ROCHESTER GAS AND ELECTRIC CORPORATION • 89 EAST AVENUE, ROCHESTER, N.Y. 14642

June 22, 1979

Subject: IE Bulletins 79-06A and 79-06A Revision I entitled "Review of
Operational Errors and System Misalignments Identified
During the Three Mile Island Incident" - additional informa-
tion requested during staff review of responses
R. E. Ginna Nuclear Power Plant, Unit No. 1
Docket No. 50-244

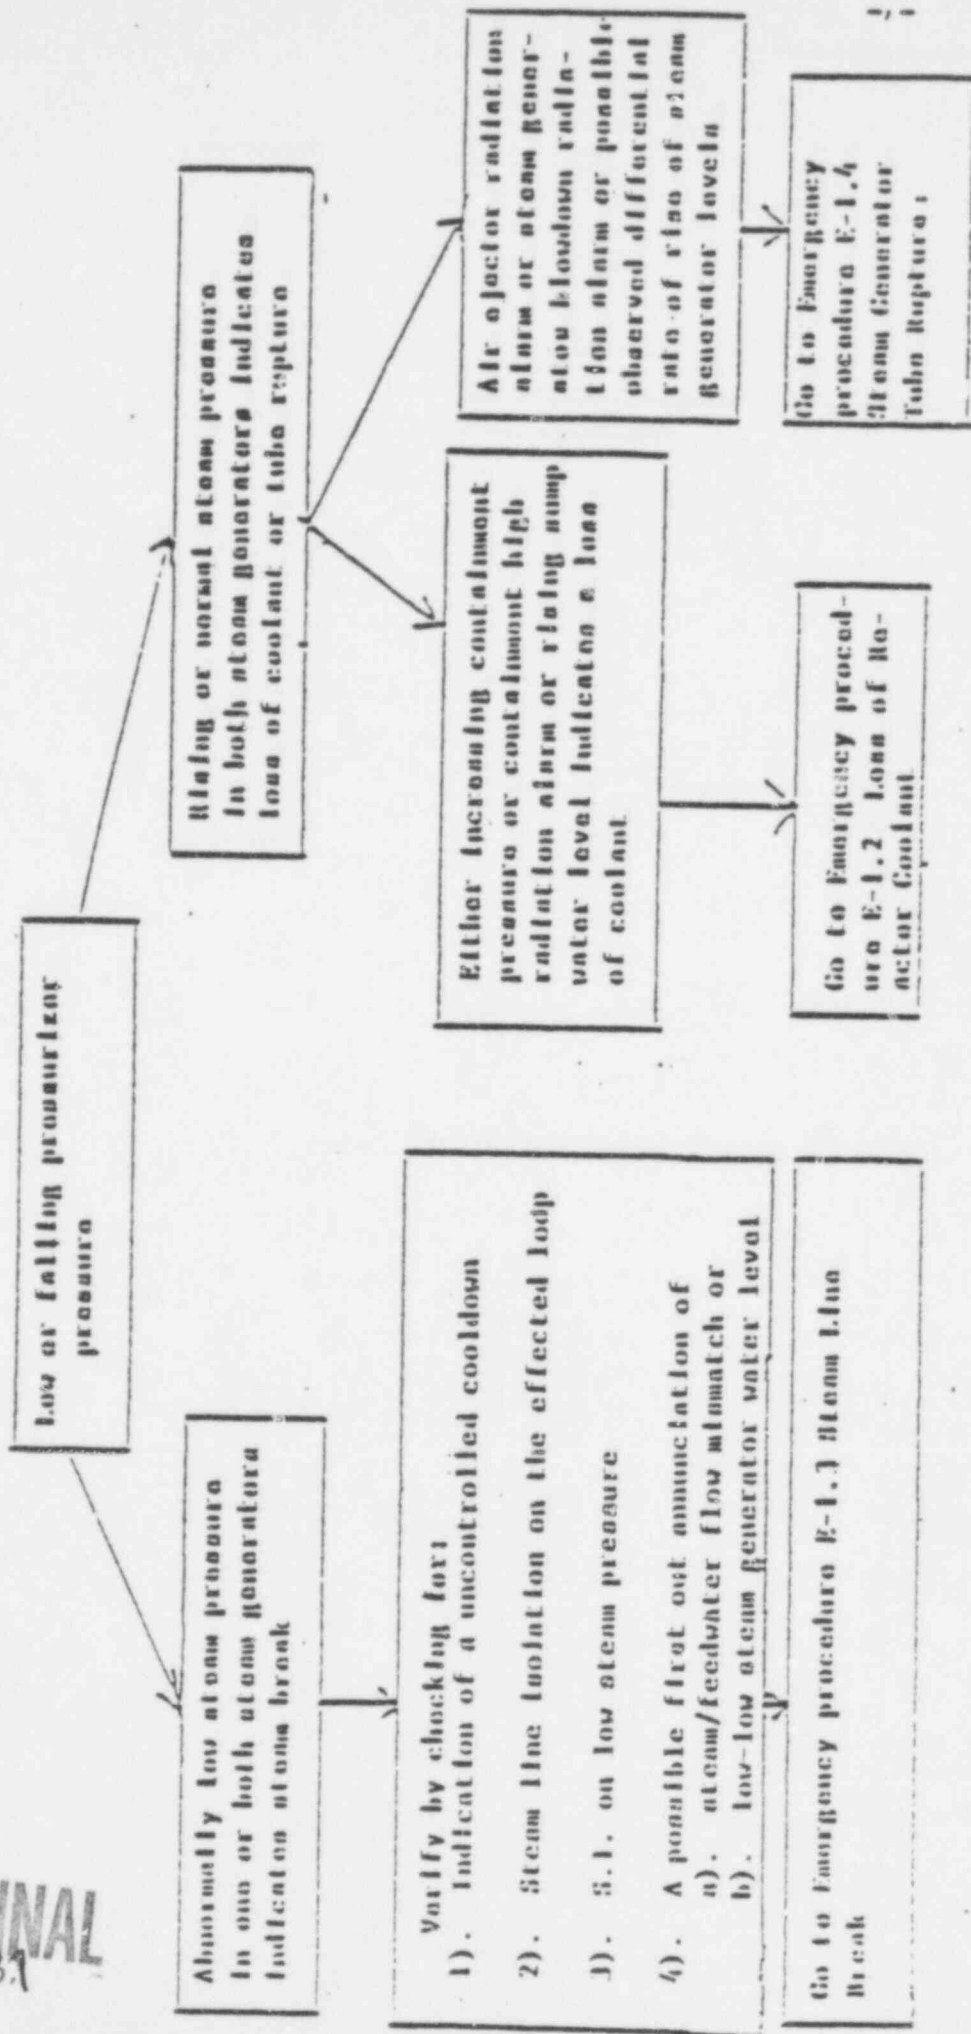
PLEASE VERIFY THAT THE IDENTIFIED PARAMETERS HAVE BEEN INCLUDED IN APPROPRIATE OPERATING PROCEDURES.

Pressurizer level has been eliminated in the diagnostic scheme for the identification of accident category. Pressurizer level has also been removed as a symptom from all RCS accident procedures except CVCS break. The operator is directed to other indications for accident identification. The diagnostic tree is attached.

The indications listed in the initial RG&E response to NRC bulletin 79-06A Rev. 1 were incorporated from the Westinghouse response to the bulletin.

All the parameters listed are not indicative of RCS water inventory. Each of these parameters except the condensate storage tank level are however, procedurally addressed in the LOCA and steam line break procedure.

The Boric acid storage tank level is addressed in LOCA and steam line break procedures in the SI pump suction change over verification to the RWST. The remaining indications listed above are symptoms of the accident, are used during the accident as operator aids for verification of safe plant conditions, are required for operator action during the accident and/or are alarmed on the control board. (The attached diagnostic tree provides an example of how the operator is instructed to consider a variety of plant indications in his evaluations).
